**SITE PLAN REVIEW COMMITTEE
MEETING AGENDA**

Item 1. SP #435 2025 Clarendon Boulevard (Wendy's/Wells Fargo) 7:00–8:25 p.m.
(RPC# 17-011-011, -012)

SP #435 2025 Clarendon Boulevard (Wendy's/Wells Fargo)
(RPC# 17-011-011, -012)

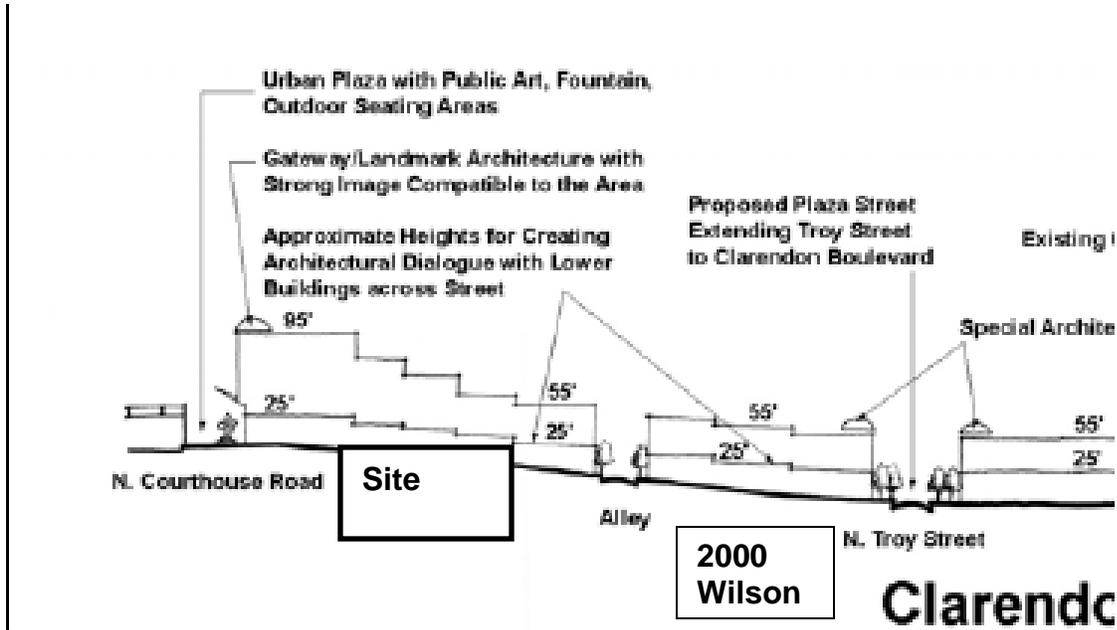
Deviations from Site-Specific Guidance (pp.26-27):

- “Buildings no higher than 10 stories generally, except vertical architectural elements at the western end.”
 - The proposed building is 12 stories. However, the *Study* also states that “Flexibility in heights could be approved to accommodate affordable housing, community facilities, special design considerations and or/new streets (p. 19).”
- “Horizontal treatment at the top of the second floor is encouraged to relate to historic buildings across Wilson Boulevard.”
 - While not in the “site specific guidance”, the *Study* additionally recommends a step back of at least 20 feet on the second level. Instead, the proposed building actually widens by 6.5 feet above the second story.

The *Study* also has additional height and taper guidance for this site on pages 13 and 14, and recommends a taper from “9 stories to 5 stories” (at the eastern property boundary) and 95 feet to 55 feet as seen in the below exhibit. Staff acknowledges that there is a discrepancy between the below exhibit (which recommends a maximum of 9 stories) and the site-specific guidance excerpted above, which recommends a maximum height of 10 stories for this site.
